Submission on Proposed Plan Change 7 – Rotokauri North Private Plan Change

Proposed Plan Change 7 Submission

Figure 15 -7a

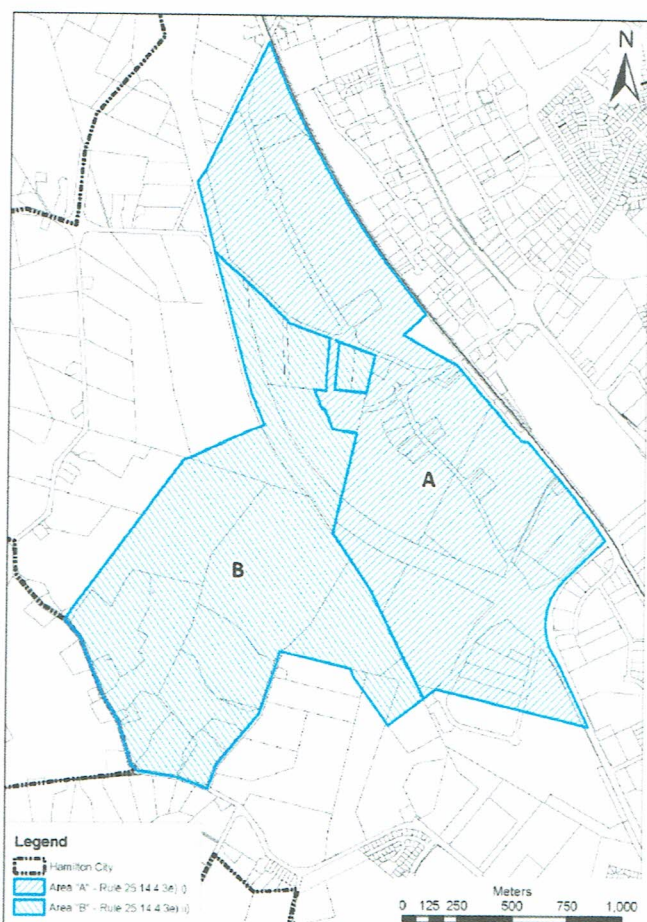
The proposed plan change is inconsistent with structure plan component “3.6.3.2 Roding” in its entirety. The proposed area is within the stage 2 area, outside of Areas A and B (see Figure 15-7a). The Rotokauri Structure Plan indicates that the release of land beyond stage 1A (such as the PPC): “will be contingent upon the availability of network capacity which may arise as a result of traffic generation” and 3.6.2.3 d and e) provide that:

Proposals for the development of land in ‘Area B’ on Figure 15-7a will require careful scrutiny to ensure that adequate network capacity exists to support the development, or will be provided as part of the development and they will not compromise the development of land in ‘Area A’ on Figure 15-7a. Development will require:

e) The development of land outside Areas ‘A’ and ‘B’ (Figure 15-7a) will need to coincide with the northwards extension of Rotokauri Minor Arterial Road to connect with Te Kowhai Road at the City Boundary.

The PPC is clearly contrary to these provisions, and the developer is trying to dodge the full cost of developing ahead of the planned sequencing by exempting itself from these Rotokauri Structure Plan provisions. The PPC does not provide adequate transport network capacity outside of the PPC area to support the proposed development. The proposal does not achieve a sustainable expansion of the city and does not represent coherent and integrated development, because the transportation effects beyond the Rotokauri North boundaries have not been resolved.

- Either decline the private plan change; or
- Decline proposed inclusion of section 3.6 d (exemption of PPC area from Rotokauri Structure Plan), but approve the development subject to requiring the developer to adhere to all existing Rotokauri structure Plan provisions, including:
 - a) requiring they construct the Rotokauri Minor Arterial Road;
 - b) provide an ITA that adequately assesses impacts on the wider transport network and have that ITA peer reviewed.
 - c) cater for the demand generated within the wider transport network;

d) requiring the developer to fund all necessary road network upgrades and additions.

e) provide a full economic assessment of the financial impact on the remainder of the Rotokauri Structure plan area and including the likely cost of the required roading upgrades.
